23 September 2019

218062  
SM/JB

## **SECTION 75W MODIFICATION – ENVIRONMENTAL ASSESSMENT REPORT CENTRAL PARK CONCEPT PLAN MP06\_0171**

**Figure 6 Comparison of approved (left) and proposed (right) public domain plan**

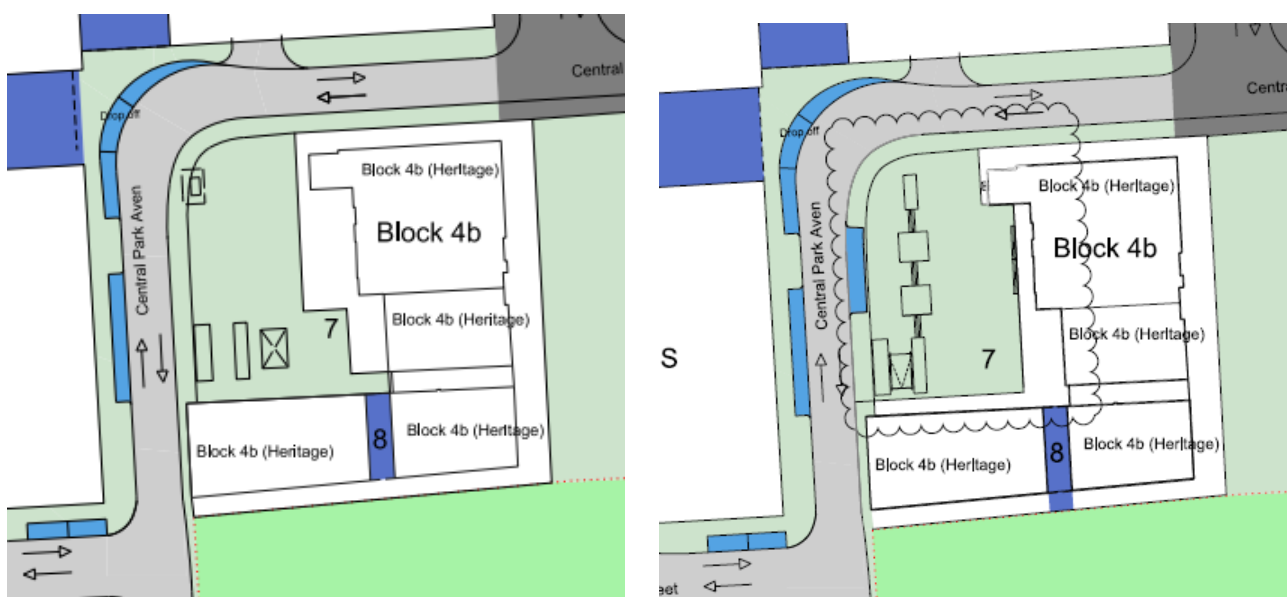
This application seeks minor amendments to the approved public domain concept in relation to the Brewery Yard boundary to align with the proposed site access arrangements in SSD 9374 that provides a loading bay on Central Park Avenue at the western boundary of Block 4B. A comparison of the approved public domain plan and proposed public domain is presented in **Figure 6**.

**Figure 7 Comparison of approved (left) and proposed (right) traffic, access and parking**

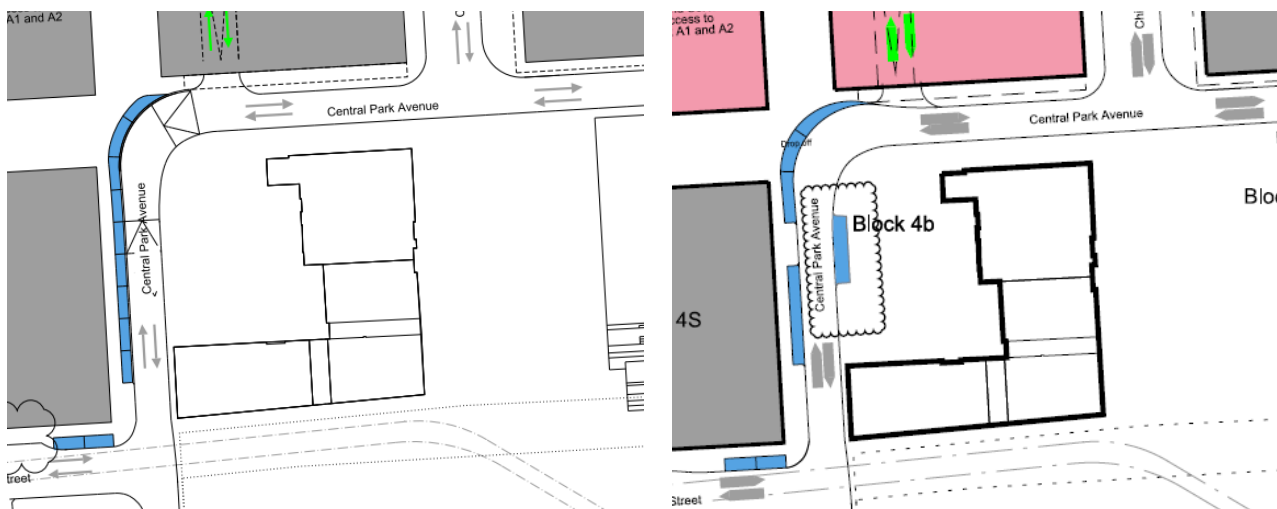
The proposed modification seeks a minor amendment to the approved traffic pedestrian and cycle routes to include the proposed loading bay adjacent to the site on Central Park Avenue. No changes to the pedestrian/cycle paths or road network are proposed. A comparison of the approved routes and proposed public domain is presented in **Figure 7**.

The proposed modifications to the approved Traffic Pedestrian and Cycle Routes plan only relate to the inclusion of one loading bay located on Central Park Avenue, at the western boundary of Block 4B to reflect the site access and loading arrangements proposed in SSD9374. This loading bay will facilitate the orderly operation of the Brewery Yard building as assessed in the Transport and Accessibility Impact Assessment (prepared by GTA Consultants) and the Operational Waste Management Plan (prepared by Waste Audit and Consultancy Services) in support of SSD9374.

**Figure 8 Proposed additions in SSD9374 in relation to the sun access plane protecting Chippendale Green**

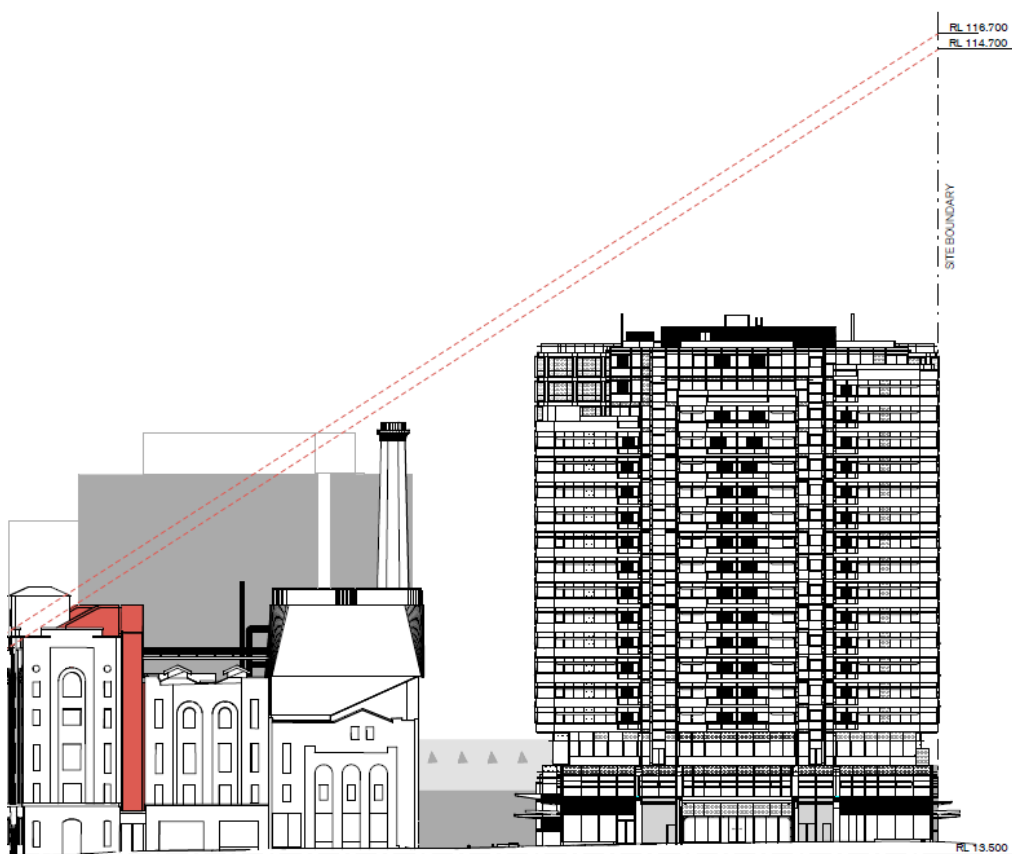
This modification to MP06\_0171 does not seek to alter the existing sun access plane of the approved Concept Plan. The proposed minor increases to both the maximum concept plan height of buildings and the maximum GFA within Block 4B is able to be accommodated below the sun access plane restrictions protecting Chippendale Green. The development as proposed in SSD9374 is compliant with the sun access plane as presented in **Figure 8**.
